ADDENDUM #1

January 29, 2018

UNC Charlotte – Baseball Indoor Training Facility
Charlotte, NC

① SITE PLAN - ELECTRICAL
1" = 20'-0"

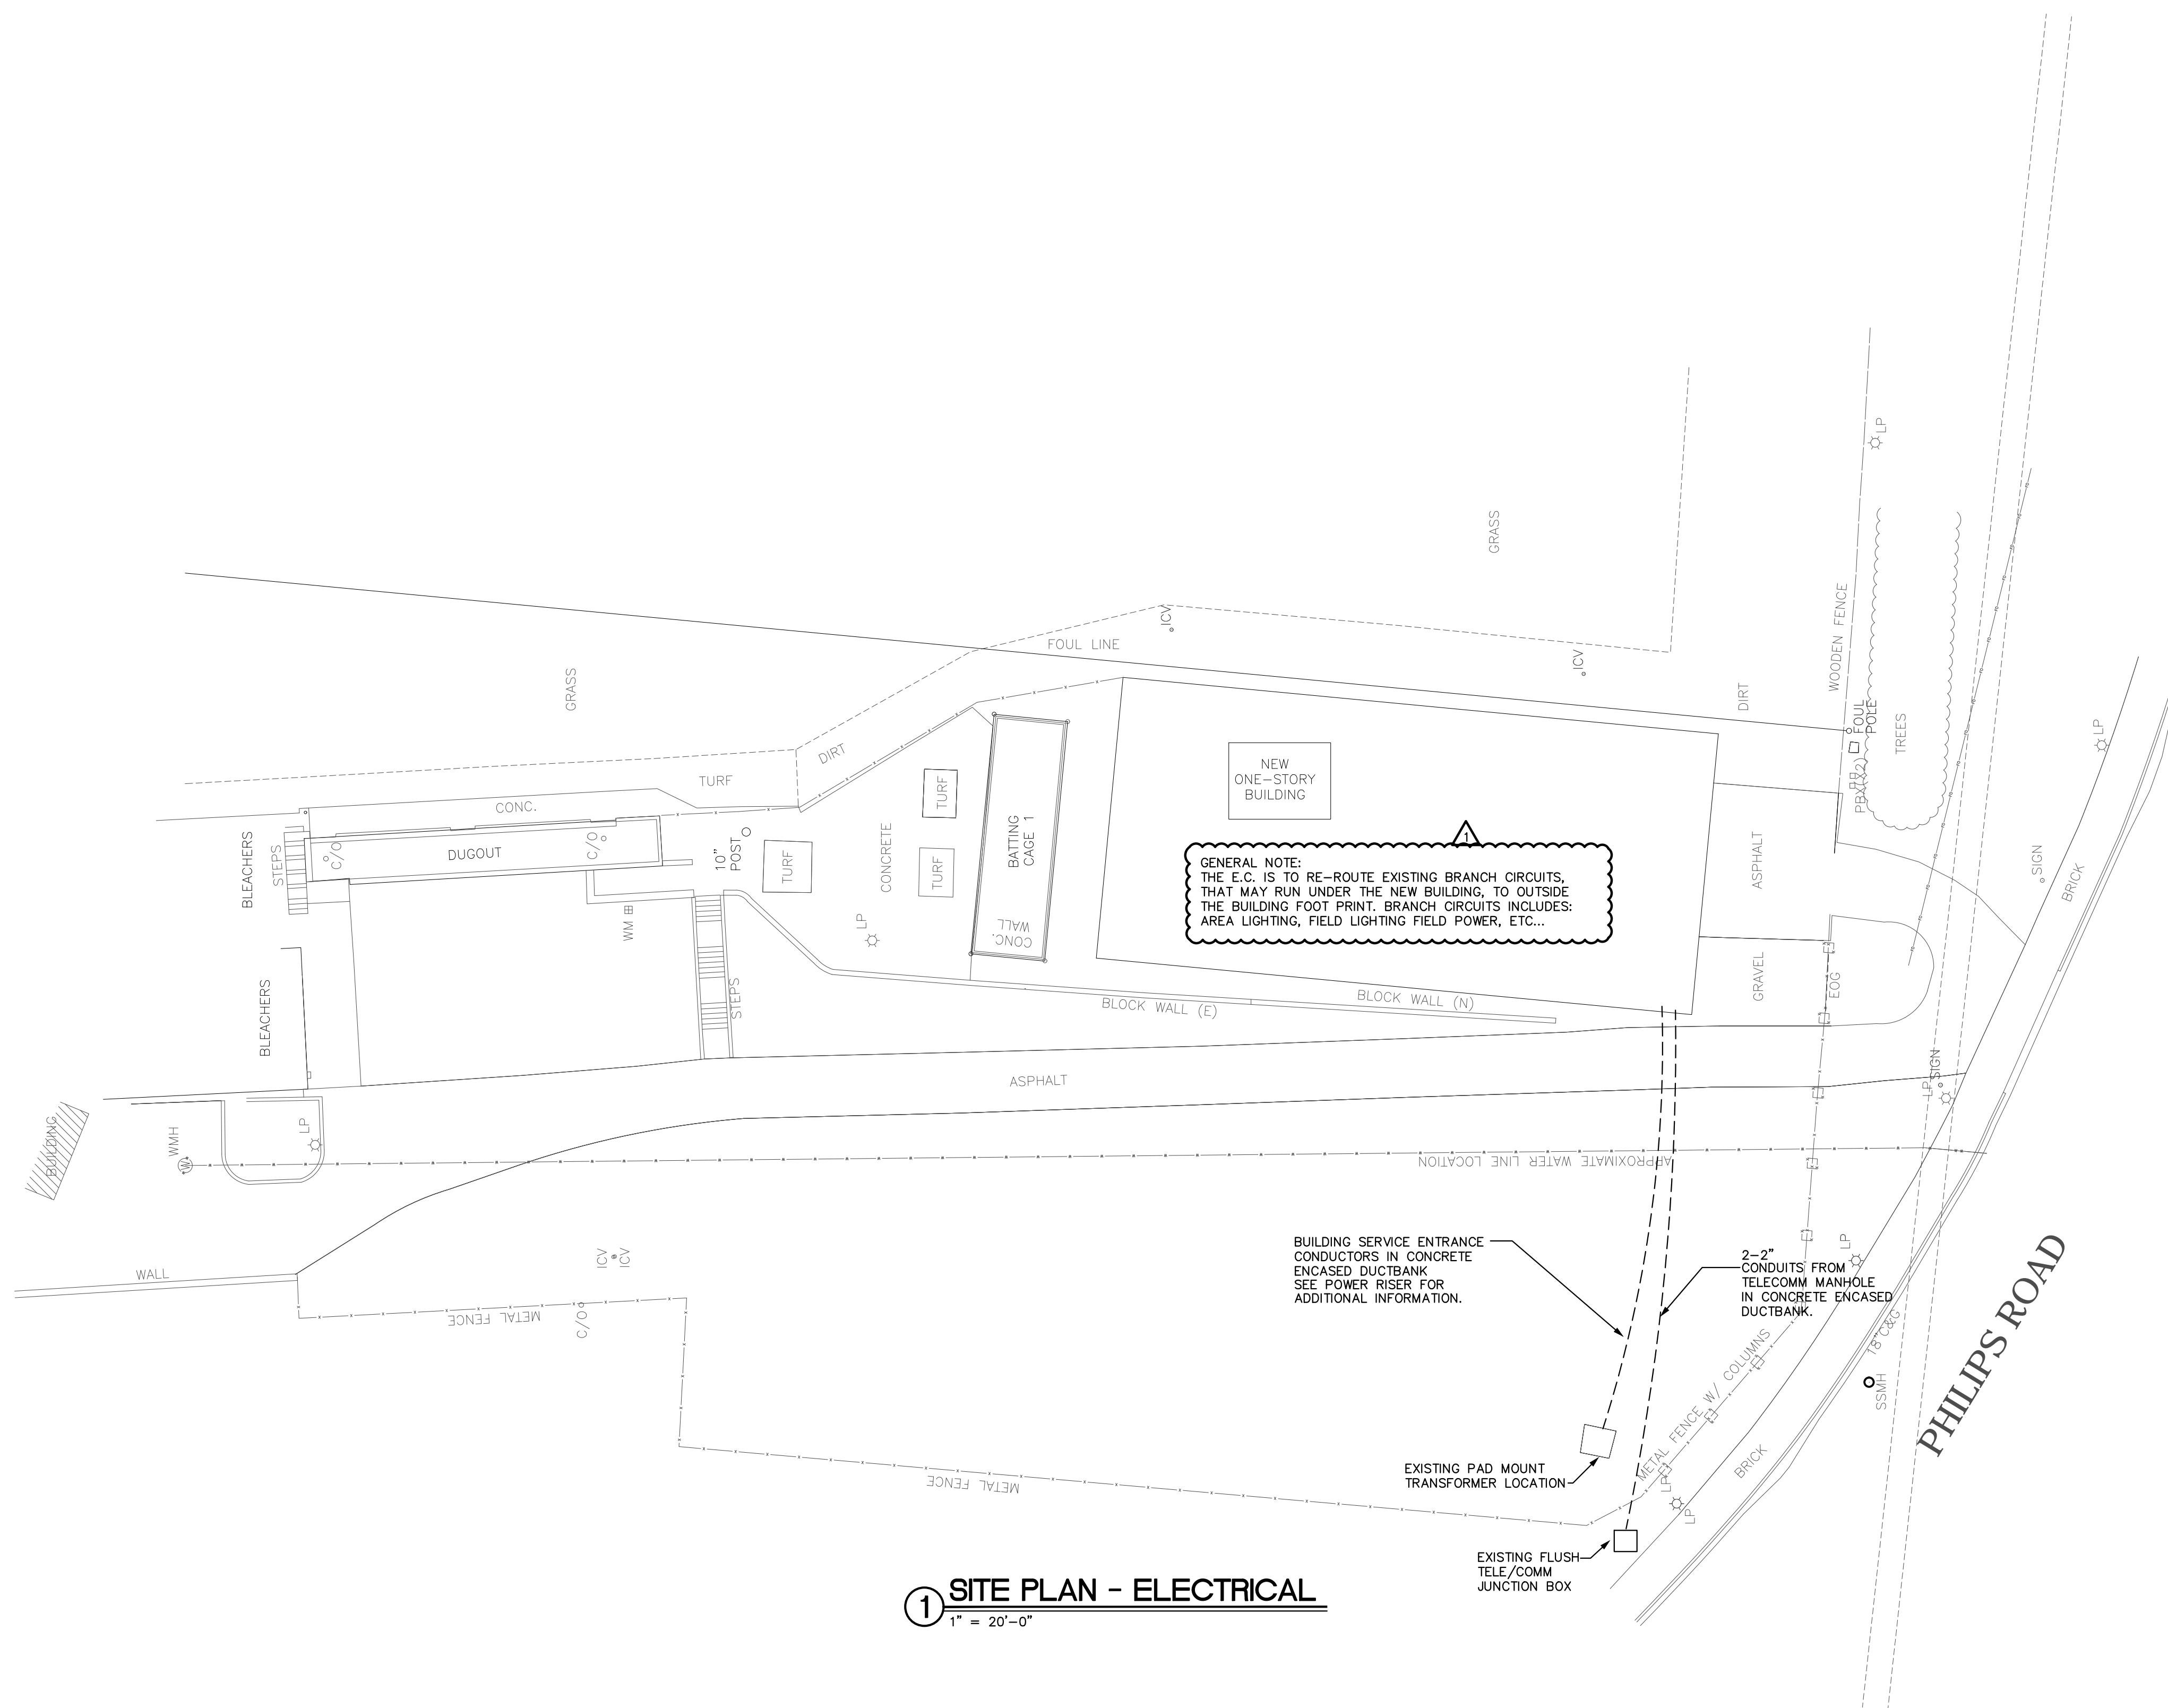
1. The contractor trailer, parking and lay-down area will be in the grassed area adjacent to the emergency drive across from the project site. The area (approximately 50'x100') is to be put back into original condition per D1 below. The area is to have temporary fencing on two sides (the existing fencing is on the other two sides)
2. See Updated Drawings E0.1, E0.3, E1.0, E2.1 and M1.1
